Memorandum

Date: June 3, 2024

Re: Re-submittal of Site Plan, 9610 and 9630 Universe Boulevard NW (PR-2020-004024/SI-2024-00648)

The following memo provides responses to staff comments for the Site Plan Administrative application heard on May 16, 2024. Staff comments are in italic followed by the Applicant responses.

OVERALL UTILITY PLAN
SCALE: 1" = 40'-0"

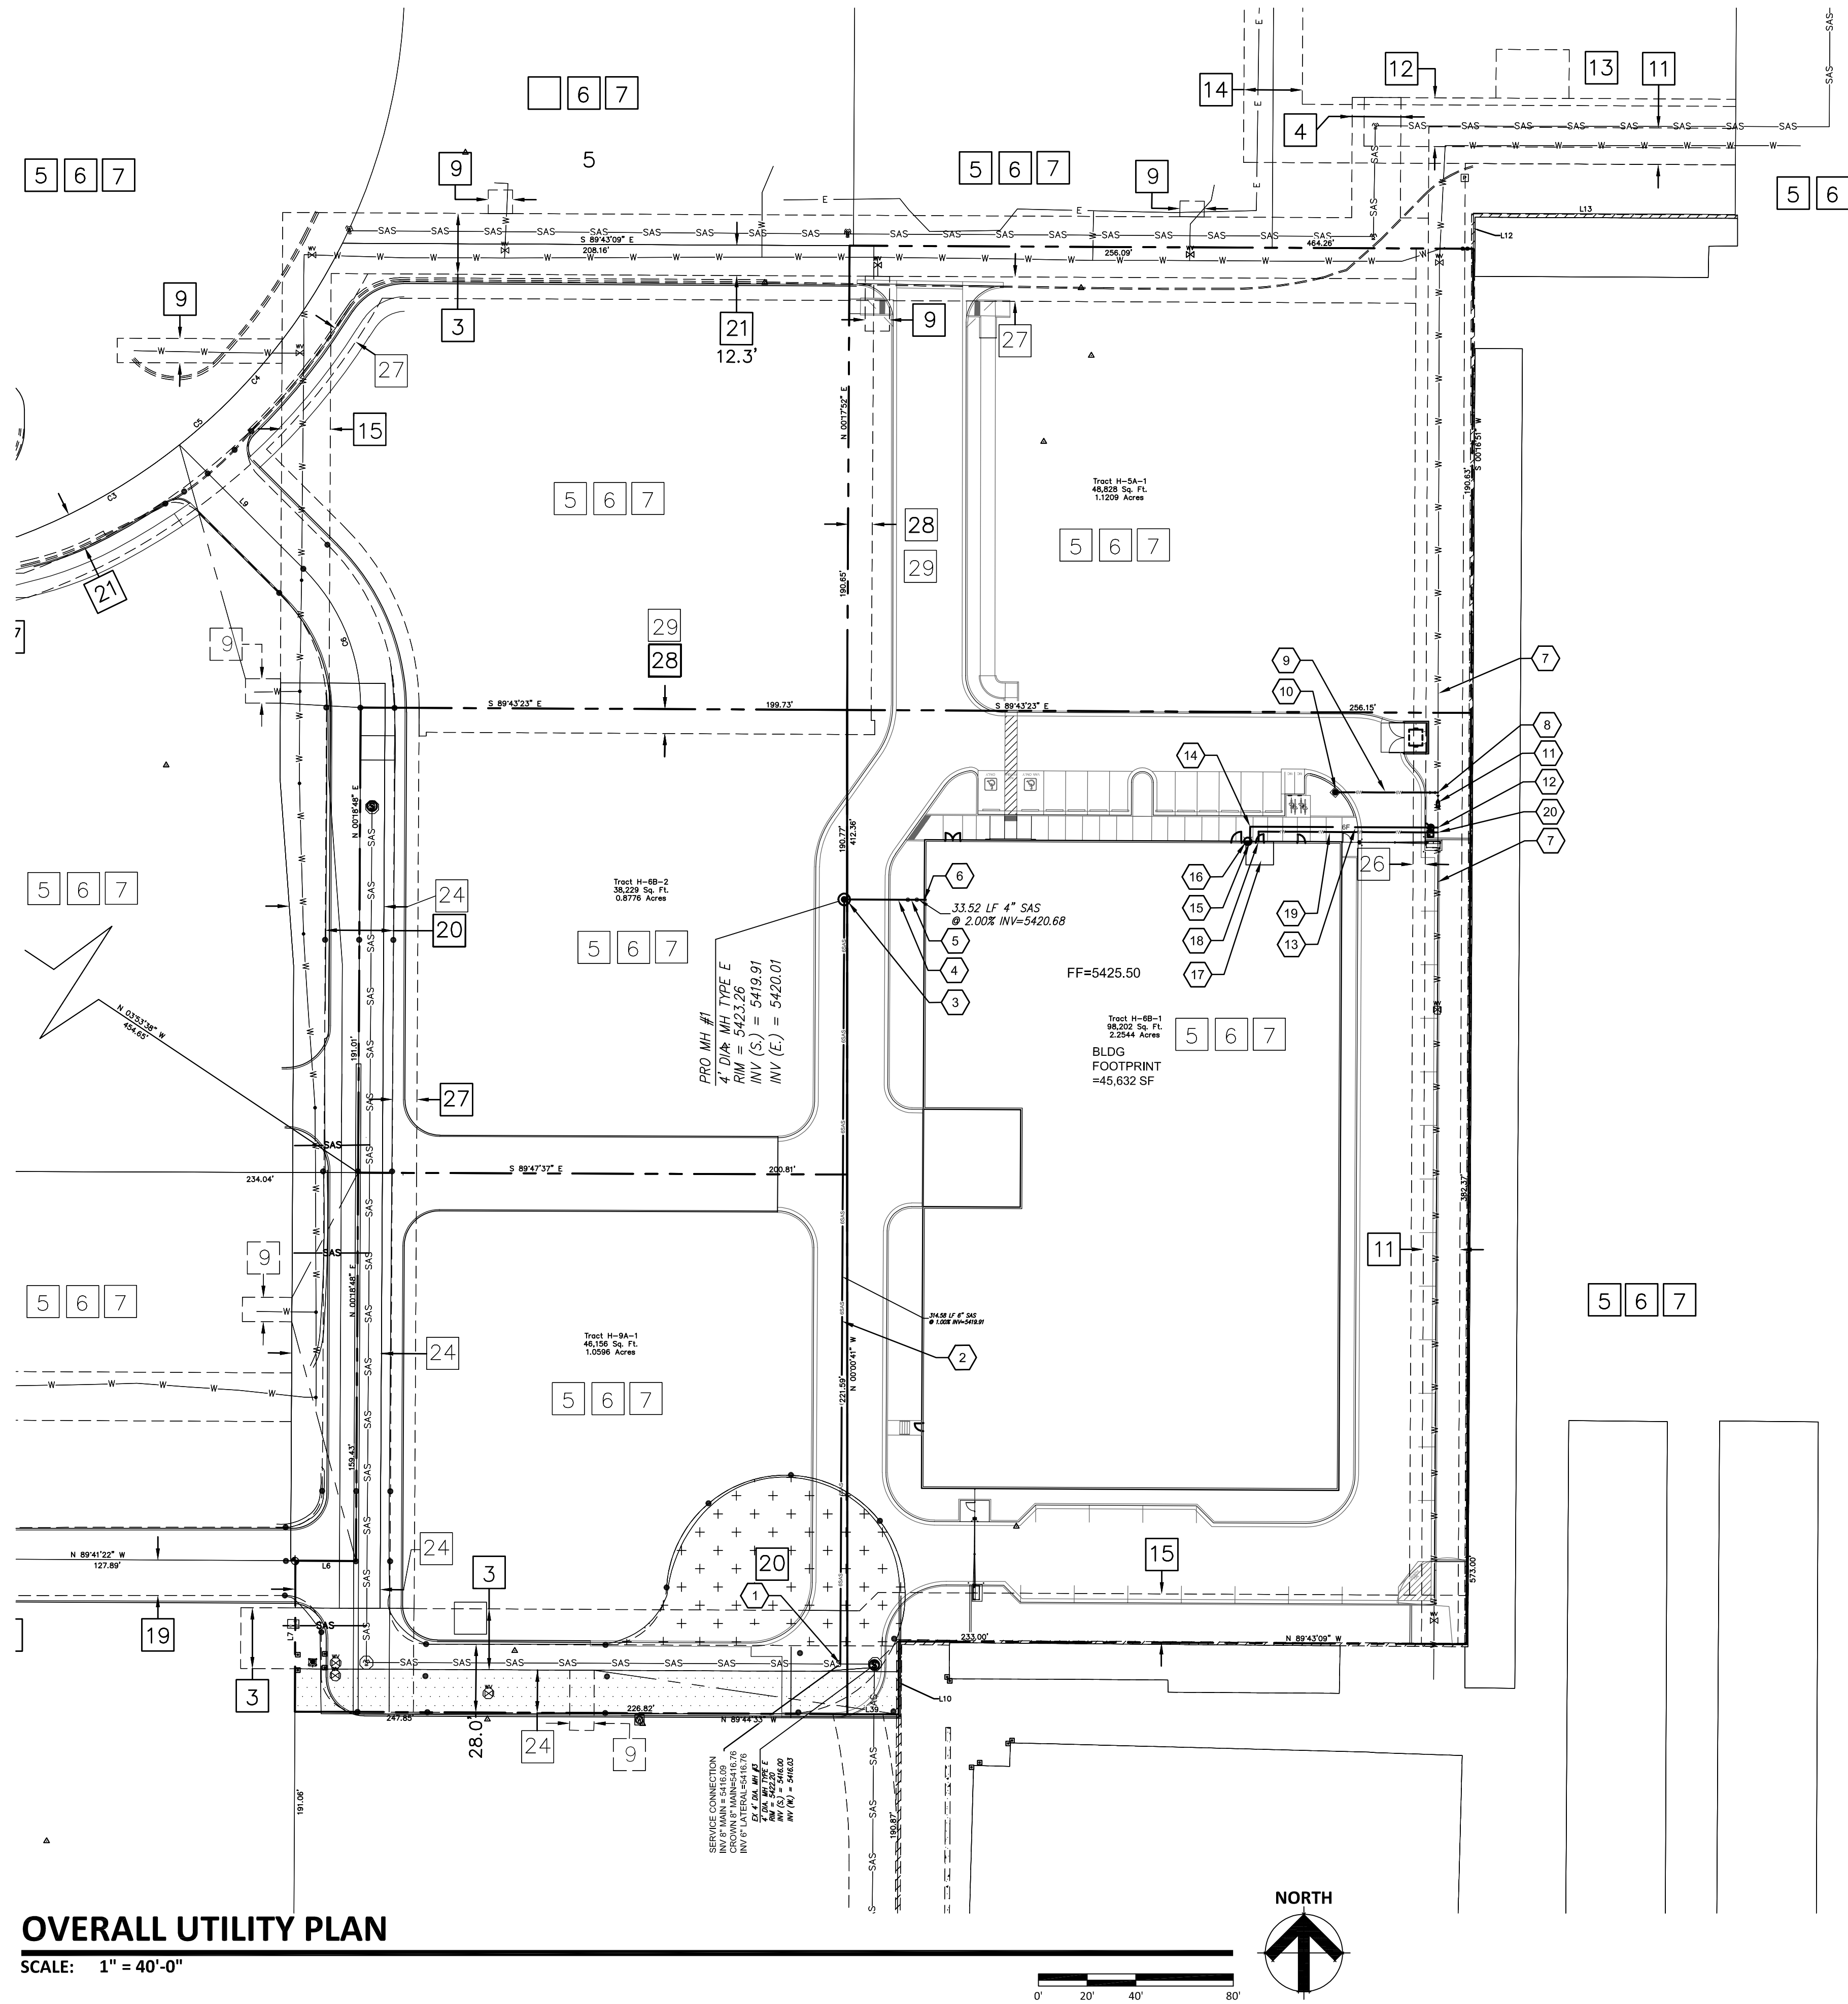
2. *Please clearly identify public vs. private infrastructure and label appropriately.*
 - a. *Some are labeled but not everything. This needs to be clear.*
 - b. *Not that all new public connections or infrastructure must be done via connection permit/work order. Maybe separate public and private in notes...as long as it is clearly labeled.*

3. *Please add the following notes to the utility plan:*
 - a. *Coordination with Water Authority Cross Connection Section will be required to ensure proper backflow containment is in place prior to release of meter for the site. Contact the Cross Connection Section at 505-289-3454.*
 - b. *Coordination with the Water Authority Pre-Treatment Engineer is required to ensure the site complies with Water Authority Sewer Use Ordinance. Contact the Pre-Treatment Engineer at 505-289-3439.*

4. *Call out the existing easements and document numbers.*

5. *Please note services must be in an acceptable location and not in traffic or parking areas. The proposed meter appears to be placed in a location that seems to not be suitable.*

Applicant Response: Agreed. Public and private labels are added.

Applicant Response: Agreed. Added to General Notes.

Applicant Response: Agreed. List of easement definitions added to plans.

Applicant Response: Meter is located behind the curb.

MATERIAL AND COLORS

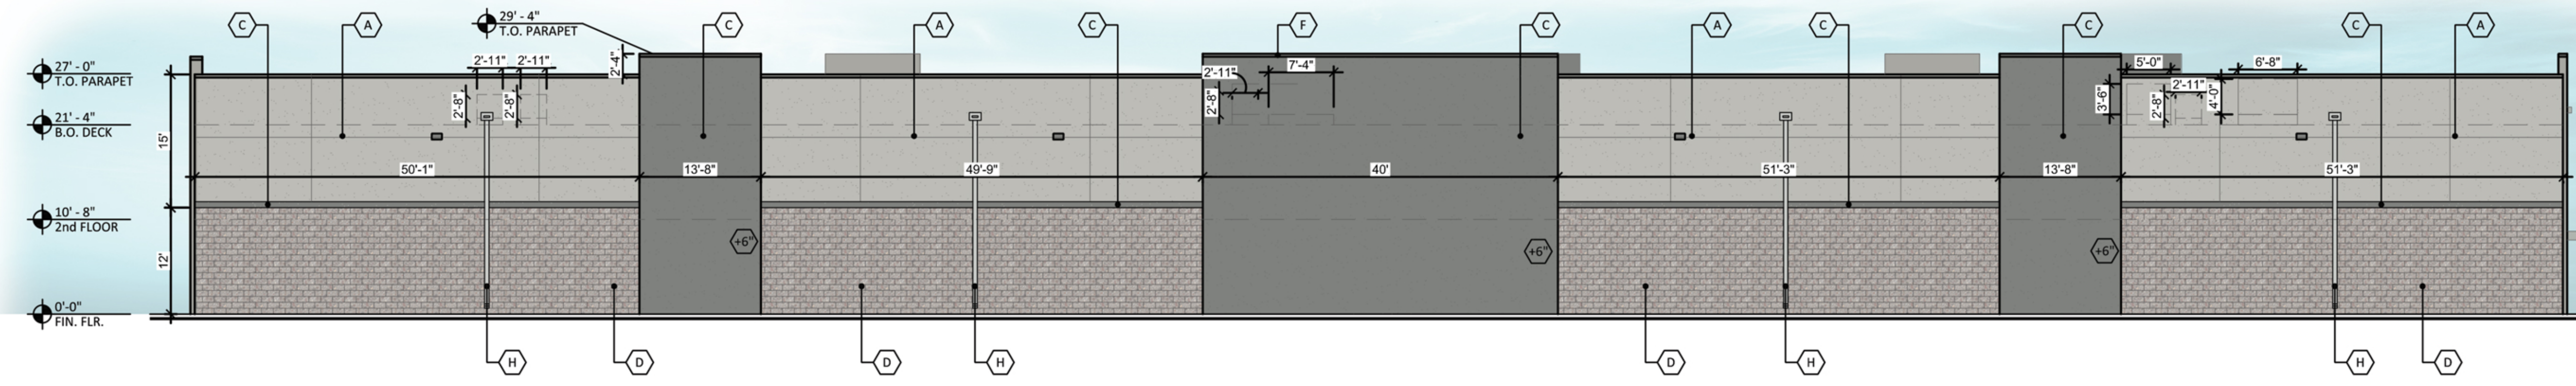
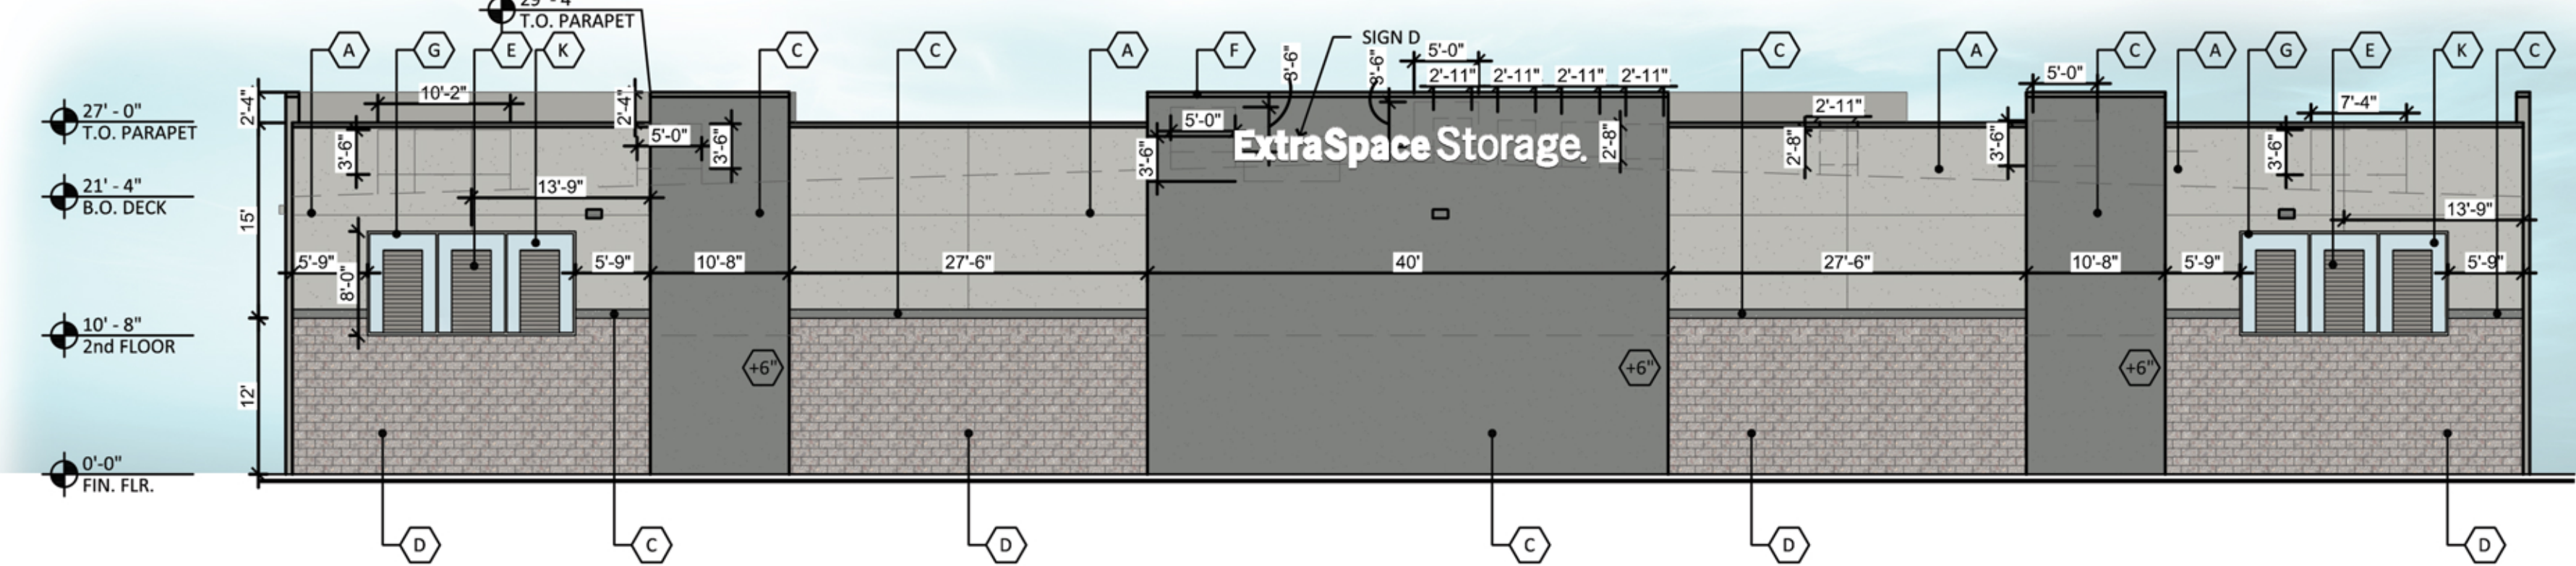
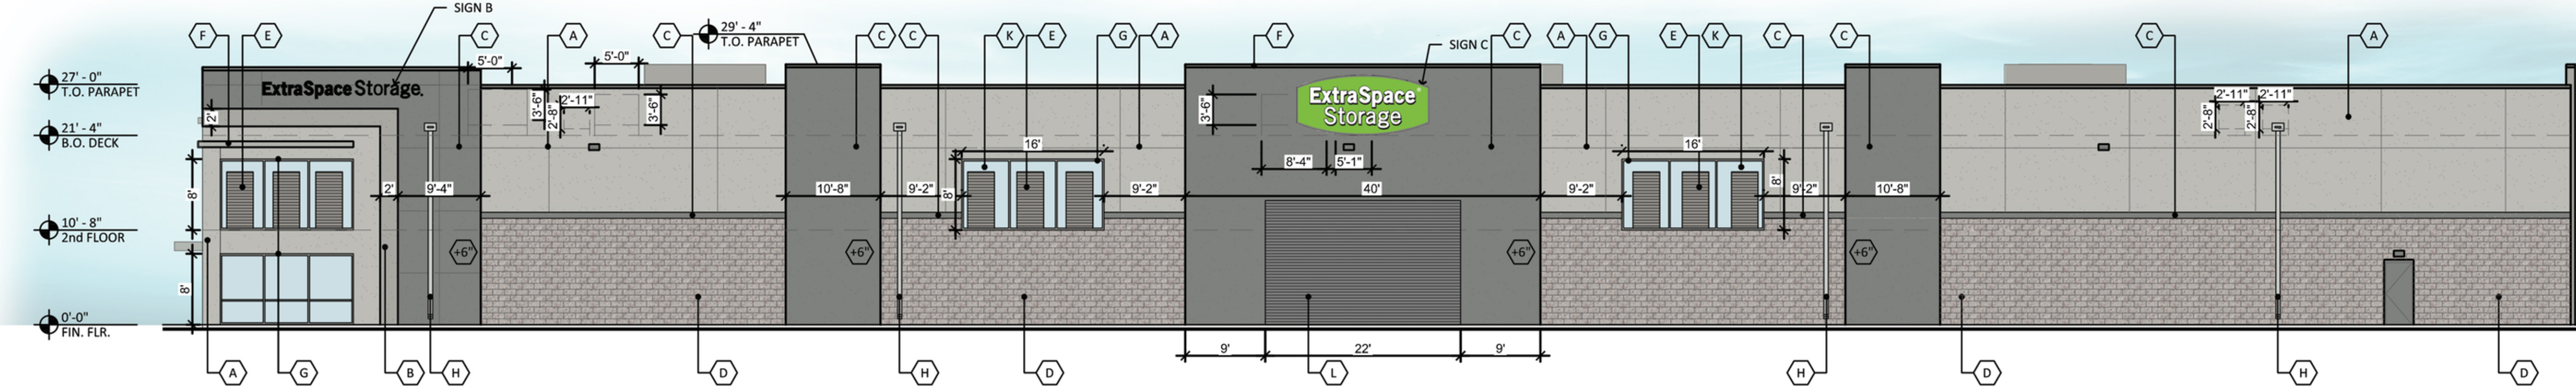
As part of the elevation pages: Provide detail to demonstrate and explain compliance with all sections within 5-11-E and 5-11-E-2. Include detail regarding how the façade and colors will meet VPO-2 requirements. Clarify if the center window design are a part of the façade or are actual windows.

Applicant Response: In response to 5-11(E)(1), the site is not within the UC-MS-PT area; therefore this criterion does not apply.

In response to 5-11(E)(2)(a)(1) – The mix of colors and materials detailed on the façade provides a clear architectural distinction between the ground floor and the second floor by providing wainscoting on the lower level and stucco on the upper level. In response to 5-11(E)(2)(a)(2) – The site does not contain a street-facing façade; therefore, the requirements in Sub-sections a - f do not apply.

The Elevation Sheet notes for Material and Colors includes details of the materials and colors on the façade. Materials include stucco and split face masonry for façade walls. The colors on the façade fall within the grey green included in the VPO-2 color palette. LRV percentages are noted for each color including finishes such as metal doors and trim. The LRV percentages range from between 21 and 50%.

The center window designs are part of the façade and are not actual windows.
